QUALITY ASSURANCE -- NON-CONFORMANCE REPORT

Report No: NCR-000619

Job Name: SAS Superstructure

Subject: NCR No. ZPMC-0592

WELD NUMBER: SSD27-PP045-047

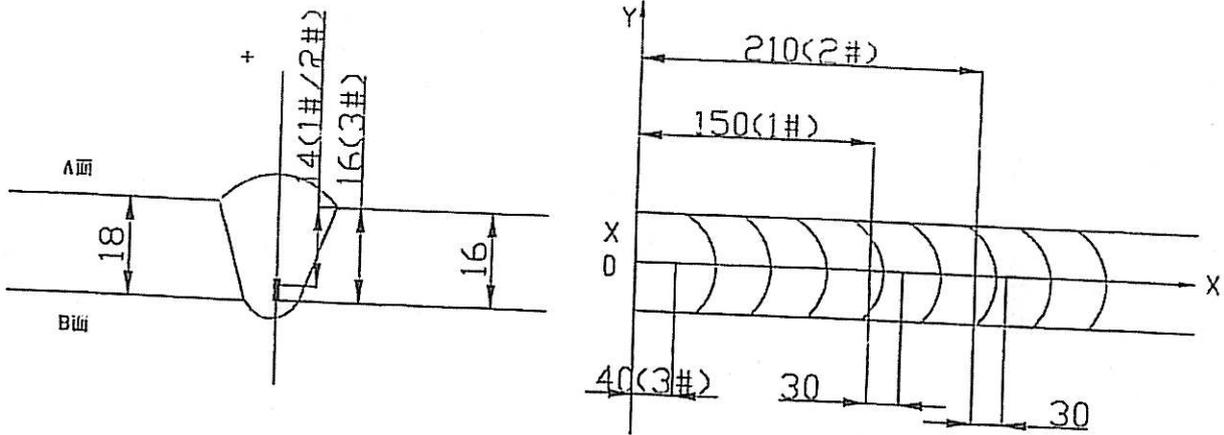
A Rejectable indication was found by Ultrasonic Inspection for a third repair.
(UT三次缺陷) SSD27-PP045-047

1. 焊工在第一次反面清根时, 没有注意, 导致焊接缺陷没有全部去除;
 2. 在焊返修前, QC没有确认所有的焊接缺陷已经去除。
1. The welder was not observant during the first backgouging operation resulting in the indications not being completely removed.
 2. QC did not verify the indications had been removed prior to re-welding.

1. 整个返修过程中, QC和Leader CWI检测所有的碳刨, 打磨和焊接;
 2. 在返修前, QC和Leader CWI应该有有效的CWR;
 3. QC和Leader CWI应该指导返修, 以保证按照返修要求进行;
 4. 碳刨前, 将杂物以及UT检测遗留的残留物清理干净, 在打磨或是碳刨前需预热到65° C;

5. 从离缺陷近的一侧碳刨或打磨的方法去除焊缝缺陷 ($D \leq 0.65T$, D为缺陷深度, T为母材厚度);
 6. 根据批准的返修WPS准备焊接接头;
 7. 将要返修的区域打磨干净, 焊接接头开始和结束的地方交错布置, 并用MT和VT检测方法保证缺陷完全被消除;
 8. 将杂物以及MT和UT检测遗留的残留物清理干净。

9. QC和Leader CWI确认报告上的缺陷已经全部去除;
 10. 根据新的返修工艺中表1进行预热以及根据批准的WPS进行焊接;
 11. 在进入下道工序前, QC目检时, 要加强对焊道的清理的监控;
 12. 焊接后根据新的返修工艺中表1要求进行后热;
 13. 后热后将焊缝逐渐冷却到周围环境温度, 并控制冷却速率不超过50° C每小时;

14. 将修补区域打磨与母材或相邻焊缝平齐;
 15. 在焊缝冷却至环境温度等48小时以后进行NDT检查;
 16. 根据批准的车间图纸VT, MT, UT检测返修后的焊缝。附加NDT检测按照合同10-1.59 “钢结构” 中的 “检测和试验” 进行。
1. QC and a Lead CWI shall be present and direct all gouging, grinding and welding operations during this repair.

2. QC and a Lead CWI shall have a copy of the CWR in hand and shall be at the repair location prior to the repair.
 3. QC and the Lead CWI shall direct the repair to ensure the repair is per the disposition requirements.

4. Clean excavation area of all loose debris including UT powder, and preheat to 65° C prior to gouging or grinding.
 5. Gouge and/or grind accurately from nearer side from metal edge ($D \leq 0.65T$, “D” is depth of defects, “T” is thickness of metal) to remove all defects.

6. Prepare a right joint according to approved WPS.
 7. Grind repair area smooth to a shiny finish with tapered ends to ensure staggered stops and starts, and perform VT and MT to ensure the defects have been removed.

8. Clean the excavation area of all loose debris including MT powder and UT gel.
 9. QC and a Lead CWI shall verify and document all defects have been removed prior to repair welding.

10. Preheat according to Table 1 and weld according to approved WPS..
 11. QC and a CWI shall enforce interpass cleaning by performing a visual inspection prior to the disposal of each pass.

12. Perform post weld heating according to the Table 1 of the New Repair Procedure.
 13. Allow the weld to cool to ambient temperature gradually. Control cooling rate after PWHT to no more than 50° C per hour.

14. Grind the repaired area flush with base metal or the adjacent weld after post weld heating.
 15. Wait 48 hours after the repair area has cooled to ambient temperature before performing NDT.

16. Check the weld by performing VT, MT and UT to the repair area according to the drawings. Additional NDT in accordance with the applicable notes in Special Provisions Section 10-1.59 ‘Steel Structure’, subsection ‘Inspection and Testing’.
